CHAMPLAIN HUDSON POWER EXPRESS
 SEGMENT 6 (PACKAGE 4A) - CP: BALLSTON TO GLENVILLE
 EROSION AND SEDIMENT CONTROL PLAN
 STA. 40308+00 TO STA. 40338+00

PERMIT DRAWING NO.	N/A
DRAWING NO.	C-411

CHAMPLAIN HUDSON POWER EXPRESS
SEGMENT 6 (PACKAGE 4A) - CP: BALLSTON TO GLENVILLE
EROSION AND SEDIMENT CONTROL PLAN
STA. 40338+00 TO STA. 40368+00

PERMIT DRAWING NO.
N/A
DRAWING NO.
C-412

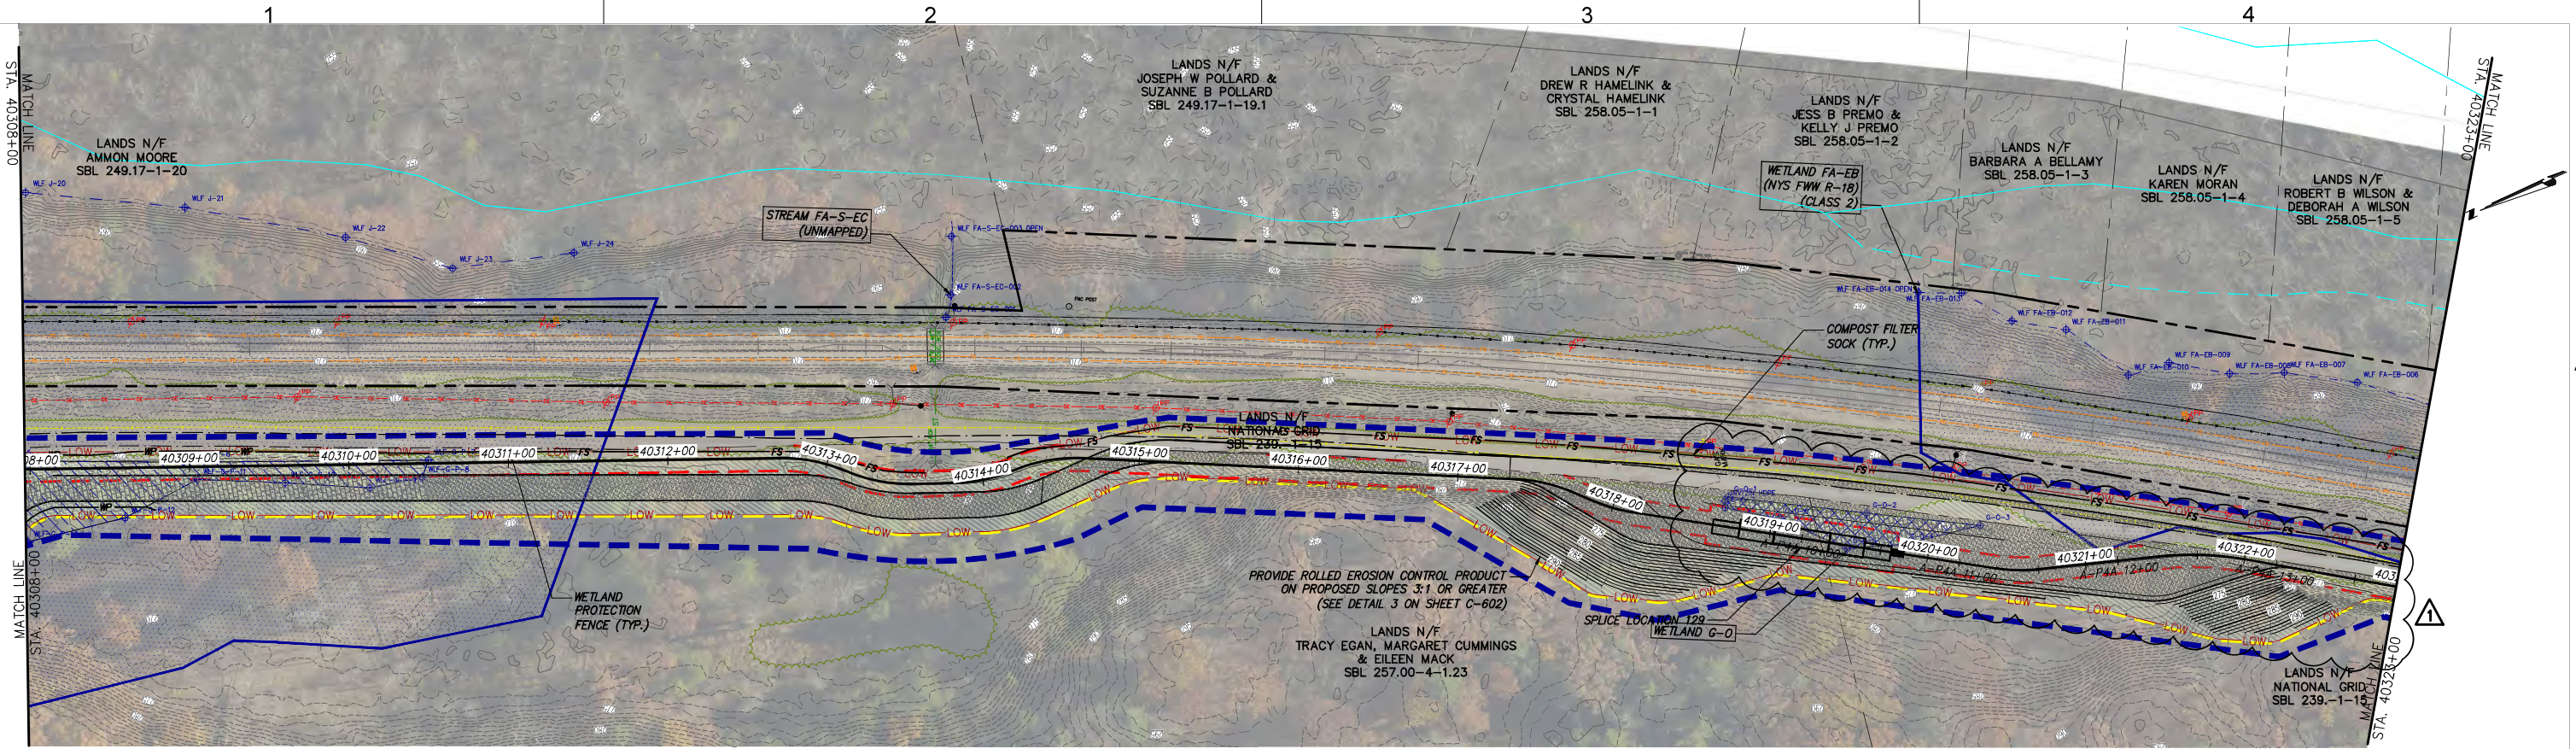
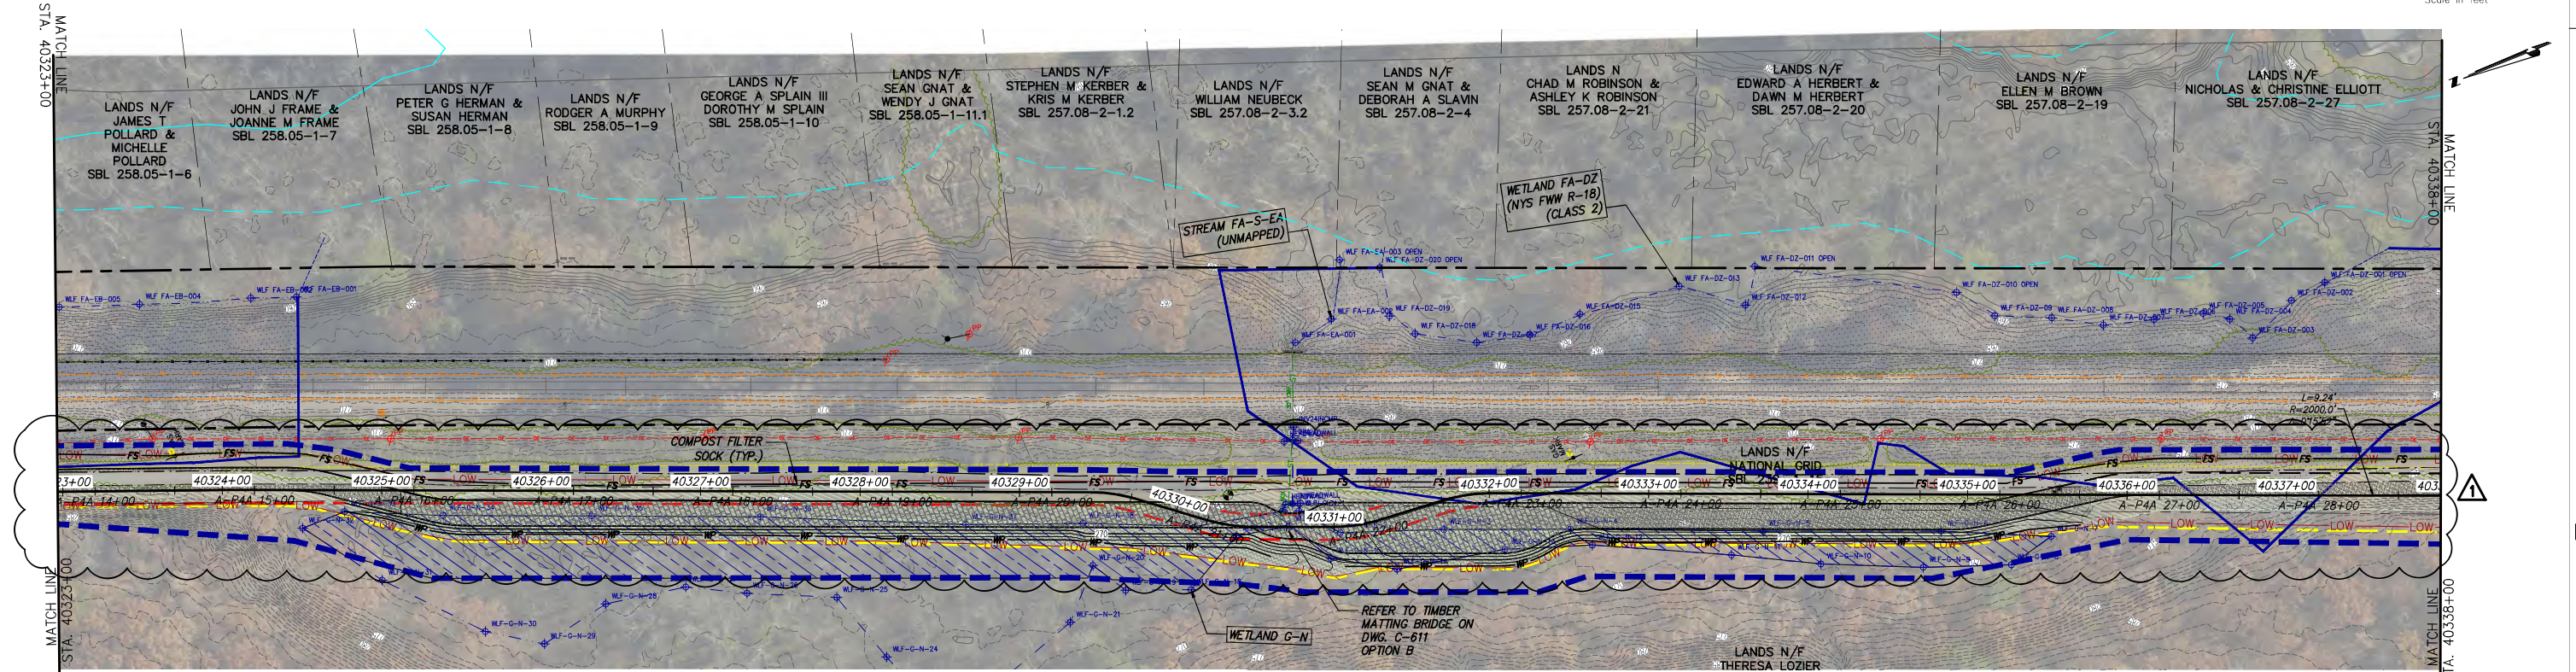
No.	DATE	SUBMITTAL / REVISION DESCRIPTION	DB	APP
1	12/18/2023	NDC-0042 ALIGNMENT ADJUSTMENT FOR FIREMAN'S LANE	JR	SL
0	08/03/2023	ISSUED FOR CONSTRUCTION SUBMISSION	BL	SL

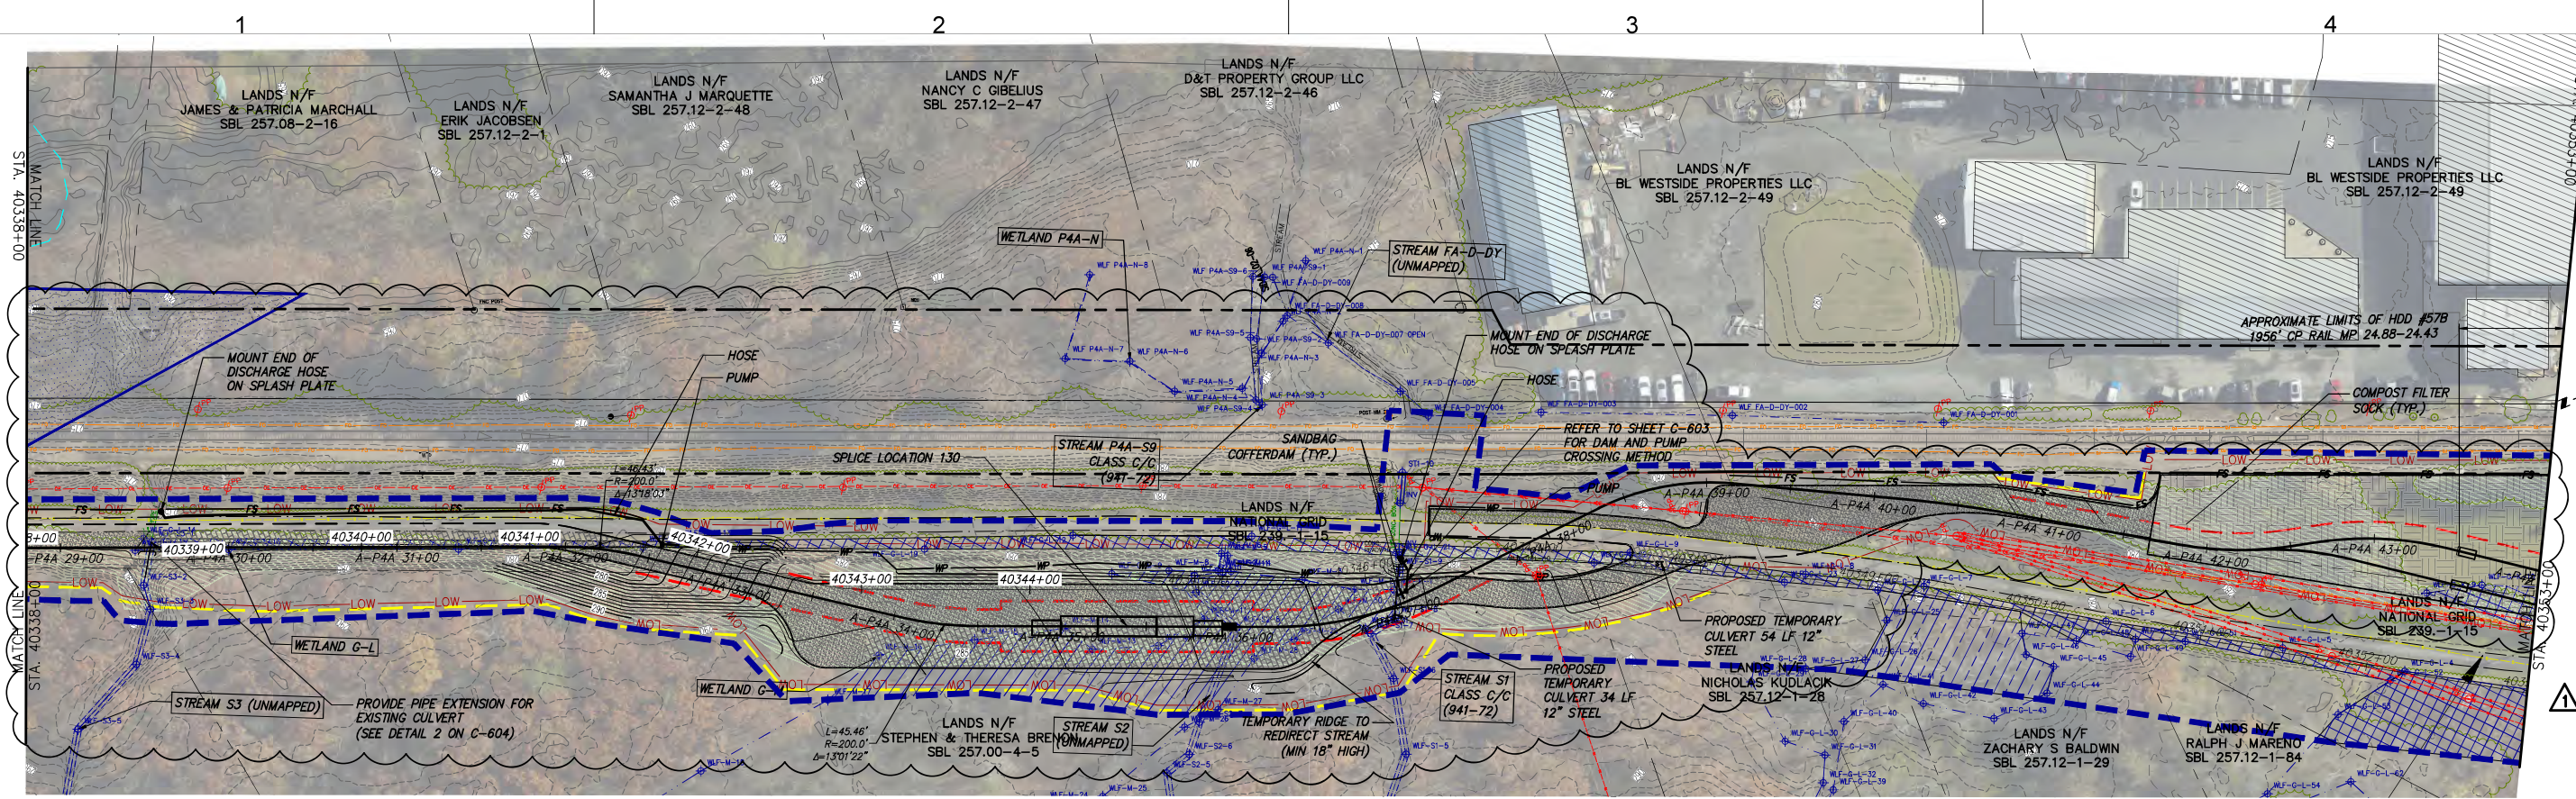
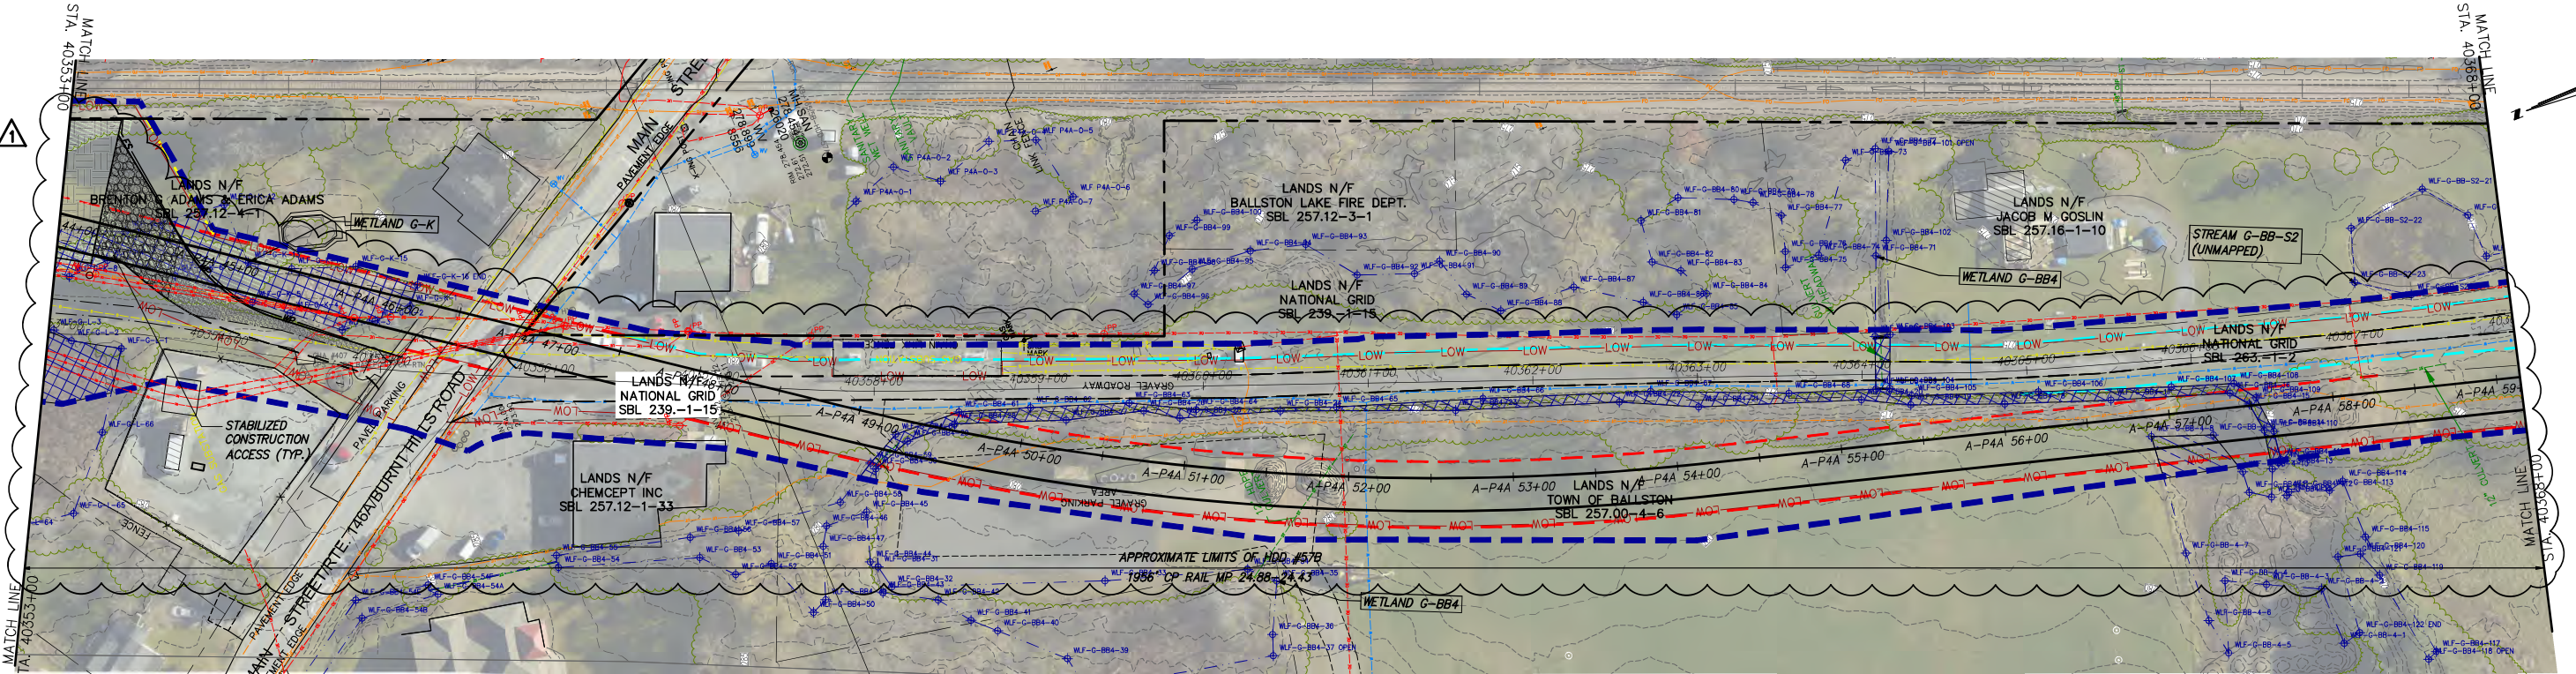
No.	DATE	SUBMITTAL / REVISION DESCRIPTION	DB	APP
1	12/18/2023	NDC-0042 ALIGNMENT ADJUSTMENT FOR FIREMAN'S LANE	JR	SL
0	08/03/2023	ISSUED FOR CONSTRUCTION SUBMISSION	BL	SL
